# Conceptual Review Agenda

# CSU Parking Garage

**Re:** CSU Parking Garage

**Description of project:** This is a request to build a parking garage on the CSU campus (Parcel #9714413904). The garage will replace an existing portion of a surface parking lot and result in a net gain of 466 parking spots. The proposed garage will be four stories. The parcel is located in the Community Commercial (CC) zone district. This proposal will be subject to Site Plan Advisory Review (SPAR).

④ SOUTHWEST

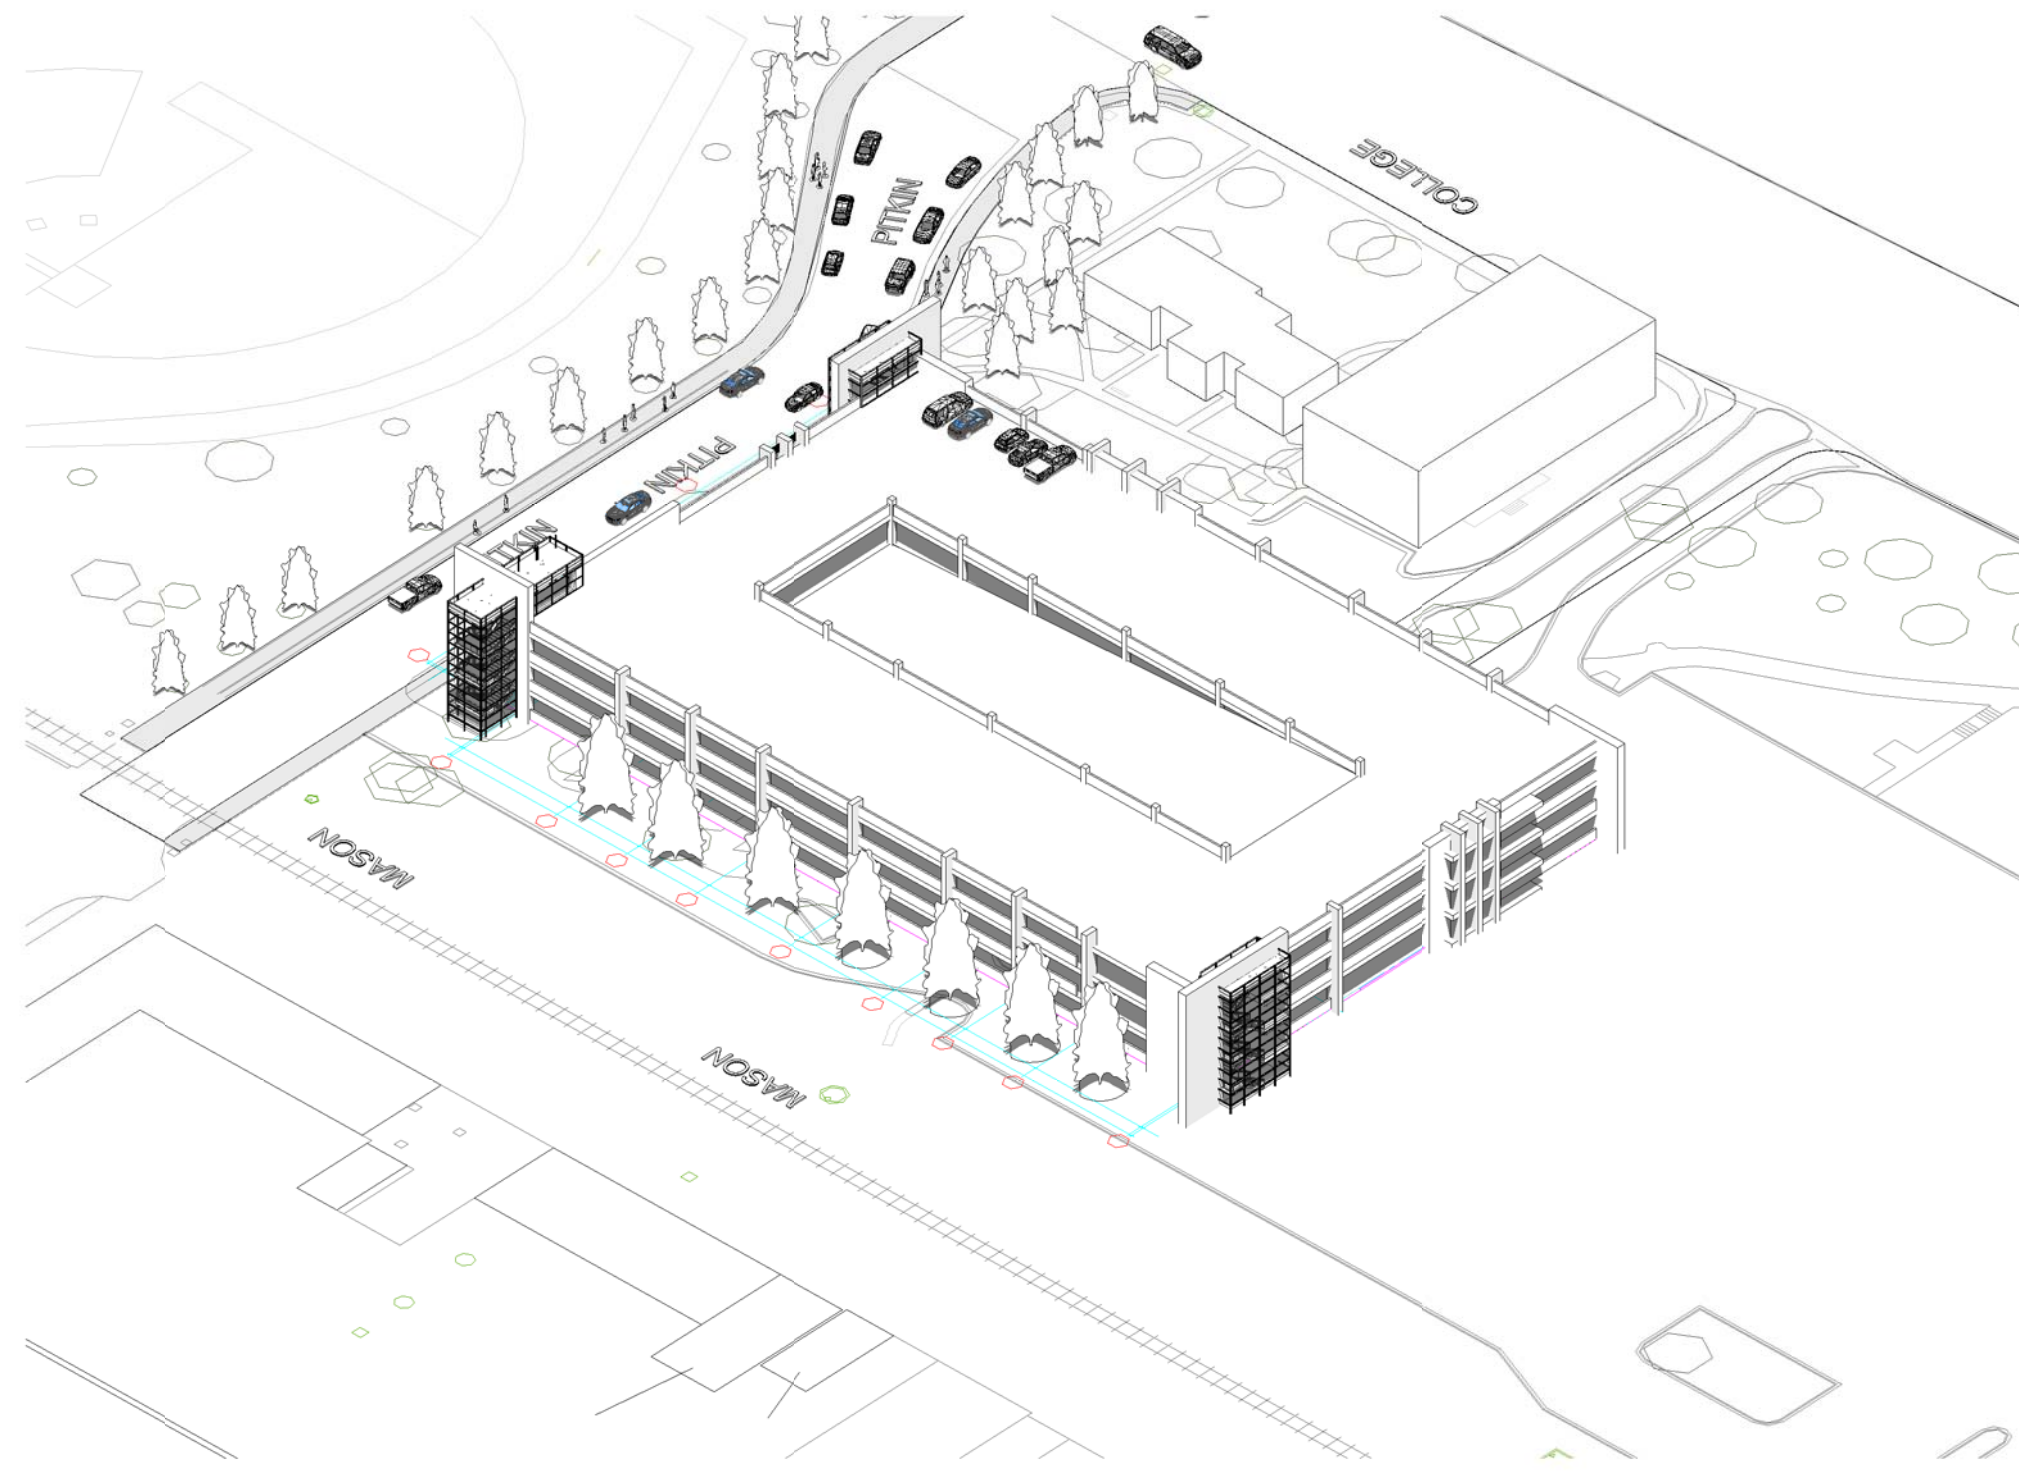
1. Regarding signage City code required a vertical sign or message be no taller than 7' in height. It appears that proposed signage shows the vertical message "PARK" to be taller than 7'.
2. No other comment.

1. It might help to clarify on the elevations the character of the glazing material enclosing the stair towers. How much opacity/reflectivity? Example photographs of materials for P&Z might be helpful.

2. Are lighting fixtures proposed on the parking structure? It would help to show the locations for new exterior lighting fixtures and clarify full cutoff/down directional lighting will be provided.
